Docket Item # 5
BAR CASE# 2009-0169

BAR Meeting
September 2, 2009

ISSUE: Signage
APPLICANT: King & Union LLC
LOCATION: 100 King Street
ZONE: KR/ King Street Retail

Figure 4. Proposed signage

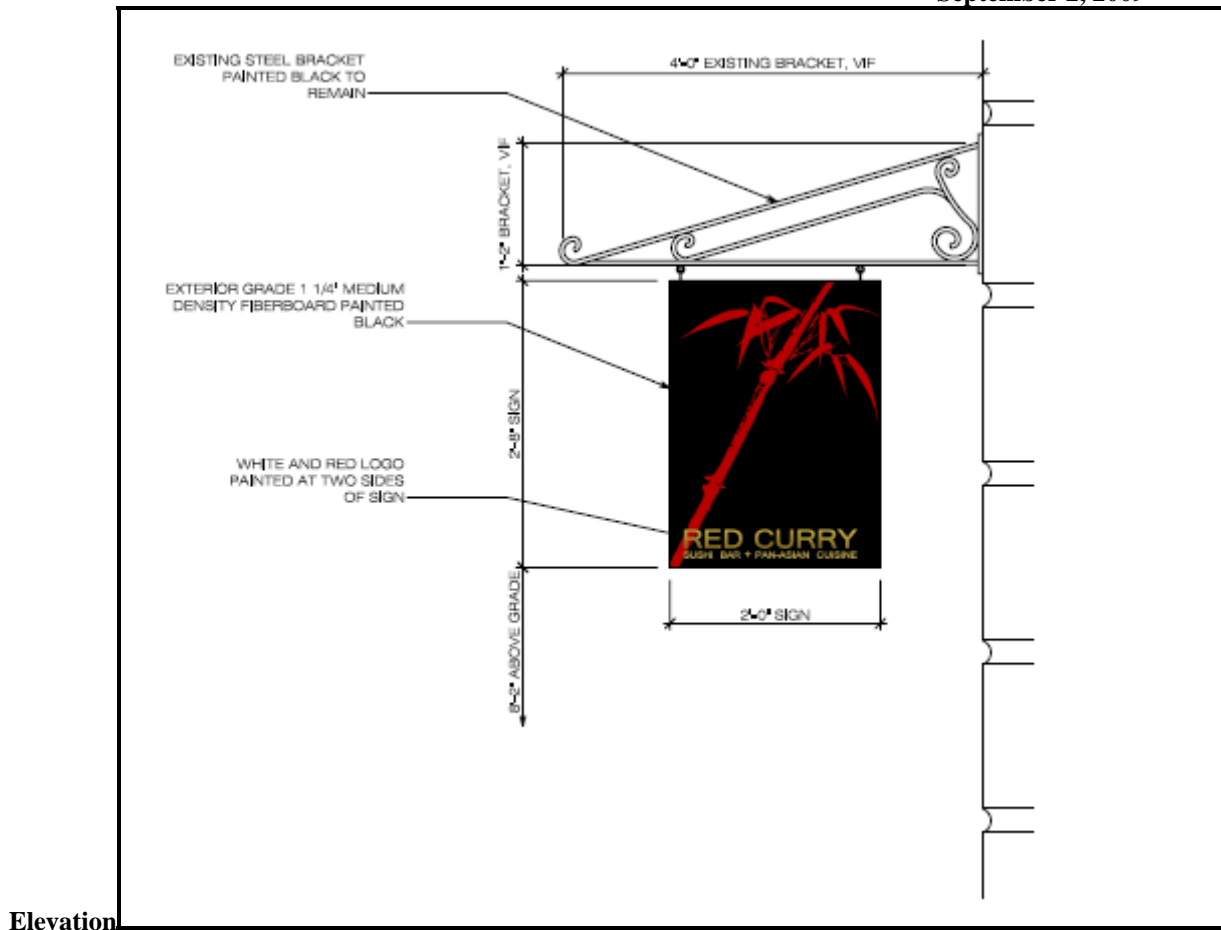
The *Design Guidelines* recommend generally only one sign per business as appropriate. On corner buildings, the Board has often approved two signs, one on each frontage of the building. Consistent with the guidelines general direction and with the Boards practice on corner buildings, it is the opinion of staff that the two proposed signs are appropriate. In addition, due to the fact that this application is for the re-branding of recently approved signs for the purpose of a restaurant change, Staff feels that the new design for the current signage is appropriate.

C-1 Wall letters / signs must comply with USBC [H103-H111] Please indicate the method to be used for anchoring the letters to the wall.

C-2 Projecting, hanging signs must comply with USBC [H103-H107, H112] for type of materials, maximum projection, vertical clearance below all parts of the sign, and additional loads.

Staff recommends approval of the application as submitted.
